NAVSHIPS 0967-066-7190

ELECTRONICS FIELD CHANGE BULLETIN
NAVAL SHIP SYSTEMS COMMAND
DEPARTMENT OF THE NAVY
WASHINGTON, D.C. 20360

12-, 15-, 16-, 18-, 19-, 20-, 21-, 22-AN/URC-32
1-, 4-, 5-, 6-, 7-AN/URC-32A
2-, 3-, 4-AN/URC-32B
3-, 6-, 7-, 9-, 10-, 11-, 12-, 13-KWT-6 (8)

Figure 1.

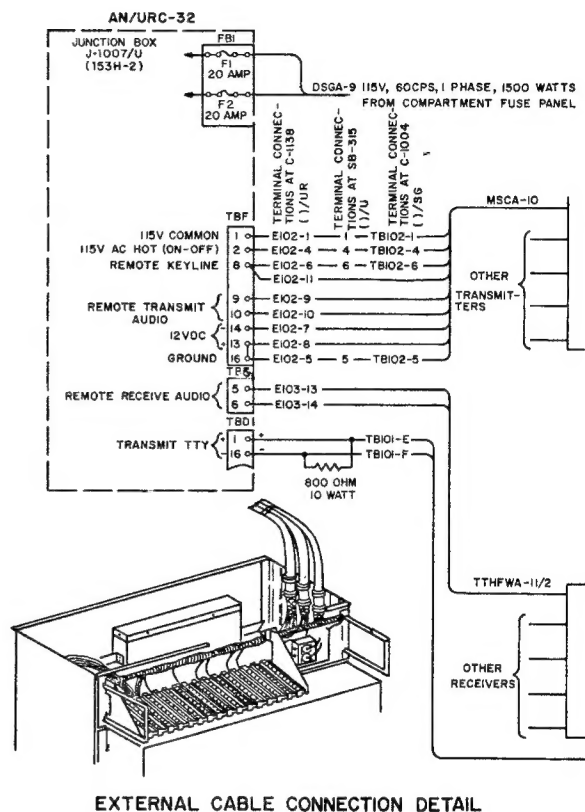
Field Change 18-AN/URC-32, 4-AN/URC-32A, 9-KWT-6/8, Junction Box (J-1007)(153H-2); Modification for 600 Ohm Output to Receiver Switchboard System-Type II, Class A; 1 Man-Hour Required

The purpose of this Field Change is to provide a 600 ohm output impedance instead of a 4 ohm impedance to the receiver audio switchboard system and to bypass the "Remote-Local" switch so that the receiver audio will be present at the switchboard at all times. It is still necessary to operate the "Remote-Local" switch for transmitter control.

Difficulty has been experienced aboard ship when paralleling the AN/URC-32 with another receiver through the audio patch panel. When the AN/URC-32 receiver is switched in, the audio from the other receiver is blanked out. This difficulty is caused by using the 4 ohm output from the AN/URC-32 series of equipments.

1. Remove cover from junction box.
2. Replace the 680 ohm resistor connected across contacts 5 and 6 of terminal board "G" with an 1800 ohm 2 watt resistor.
3. Connect audio cable to remote system on contacts 5 and 6 of terminal board "G" instead of Contacts 11 and 12 on terminal board "F".

Figure 2. Receiver overload protective device after field change.

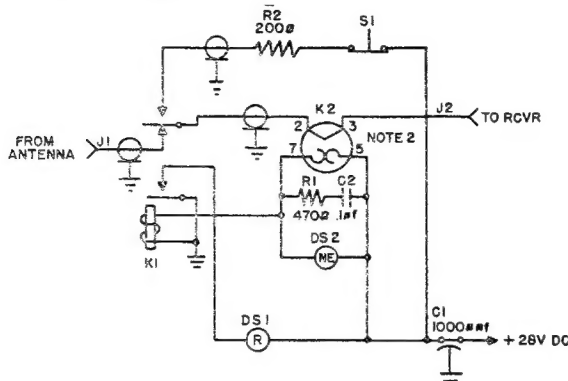
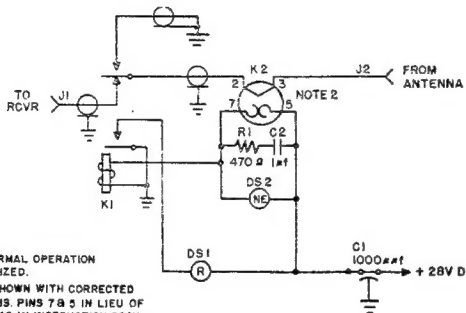
Field Change 20-AN/URC-32, 6-AN/URC-32A, 3-AN/URC-32B, 11-KWT-6(8)- Wiring Change to Receiver Overload Protective Device; Type II, Class A; 1 Man-Hour Required.

The purpose of this field change is to provide automatic reset after an overload condition.

NOTES:
1. SHOWN IN NORMAL OPERATION
K1 IS ENERGIZED.
2. RELAY K2 SHOWN WITH CORRECTED
CONNECTIONS. PINS 7 & 5 IN LIEU OF
PINS 7 & 4 AS IN INSTRUCTION BOOK.

4. Remove the coaxial lead connected between relay (K1) and resistor (R2) (200 ohms, 5 W, 5 percent).

5. Shorten the coaxial cable, removed in step 4, to within 1 inch of the BNC connector. Remove 1/2 inch of the outer insulation. Push the braided shield back and remove 3/8 inch of the dielectric from the center conductor. Pull the shield over the conductor and solder the conductor and shield together.

6. Connect the grounded BNC connector to K1 as removed in step 4. Replace bottom cover.
7. Stencil "ANTENNA INPUT" adjacent to J2. Stencil "TO RECEIVER" adjacent to J1.
8. Reinstall the protective device in the AN/URC-32. Connect leads removed in step 2 (Cable W-27 or antenna cable will connect to J2, Cable W-3 will connect to J1).
9. Return equipment to normal operation.

Figure 1. Modification performed.

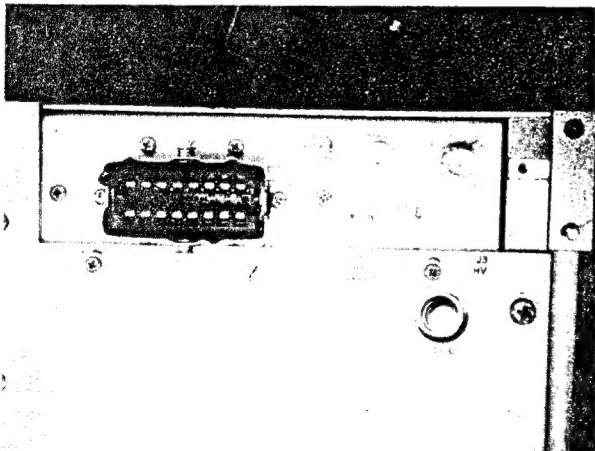
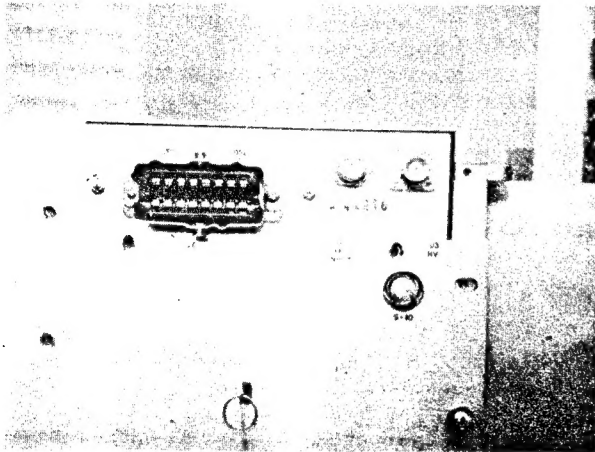
Field Change 21-AN/URC-32, 7-AN/URC-32A, 4-AN/URC-32B, 12-KWT-6(8)-Modification to the Radio Frequency Amplifier, AM-2061/URT RF Input Receptacle, 2J1, and Plug, 15W2P1; Type II, Class A; 1 Man-Hour Required

The purpose of this field change is to provide dissimilar receptacles and plugs which will prevent the inadvertent reversal of the RF input plug, 15W2P1, and high voltage plug, 15W9P1, in the Radio Frequency Amplifier, AM-2061/URT.

5. Remove 2J1, R.F. input receptacle, type UG-931/U, from the mounting bracket. NOTE: 2J1 is the center connector on the mounting bracket (see figure 1).

7. Assemble the new, DAGE No. 8009-1, connector on the coaxial cable.

8. Install the new connector, DAGE No. 8009-1, on the mounting bracket.

12. Assemble the new connector, DAGE No. 8000-1, on the coaxial cable W2.
